WATER QUALITY M E M O R A N D U M Utah Coal Regulatory Program

RE: 2010 Fourth Quarter Water Monitoring, Hidden Splendor Resources, Inc.,
Horizon Mine, C/007/0020 WQ10-4, Task ID #3683

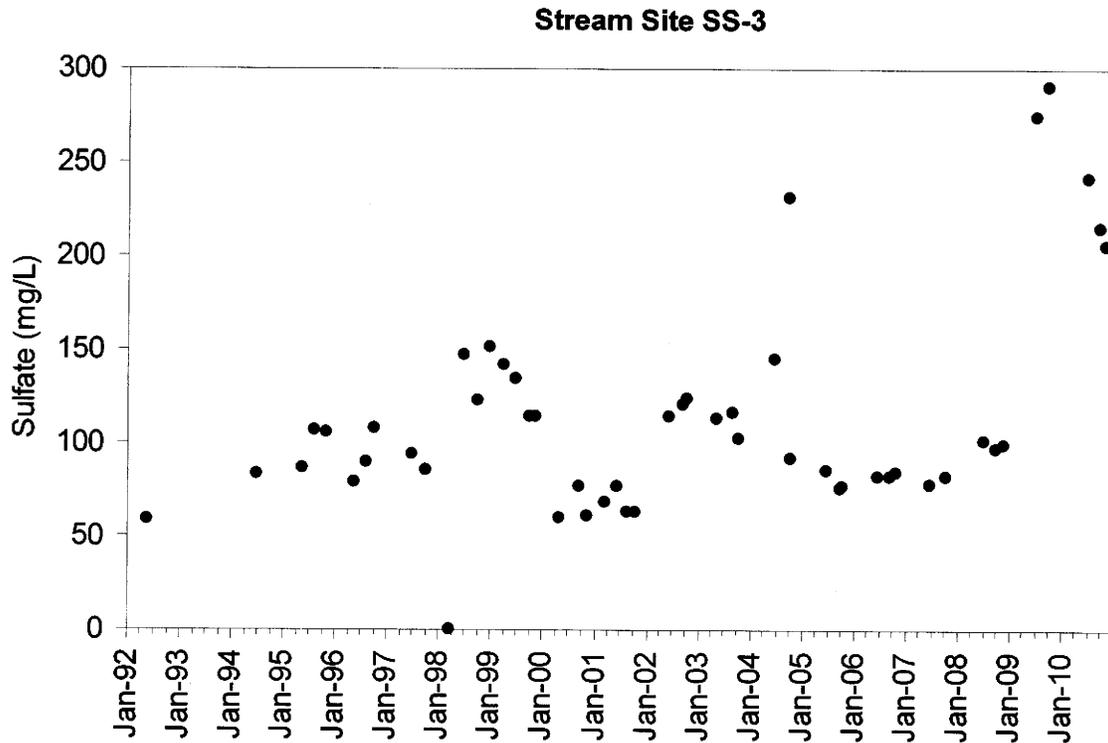
The conductivity measured at site SS-3 (Jewkes Creek below mine) on November 1, 2010 was reported at 1140 $\mu\text{S}/\text{cm}$, which is greater than the average value of 699 $\mu\text{S}/\text{cm}$ by 2.39 times the standard deviation of 184.41 $\mu\text{S}/\text{cm}$. As shown in the plot below, the ratio of conductivity to total dissolved solids for fourth quarter 2010 is consistent with the trend line for historical measurements at location SS-3.

Sulfate concentrations at station SS-3 are variable, but appear to have been elevated during recent sampling events (see plot below). The sulfate concentration apparently spiked during second quarter 2009 to a maximum of 290 mg/L during third quarter 2009. Since then, sulfate levels have decreased and the fourth quarter 2010 sulfate concentration was reported as 205 mg/L. The sulfate concentration at SS-3 remains above the concentrations which were reported before the second and third quarter 2009 spike.
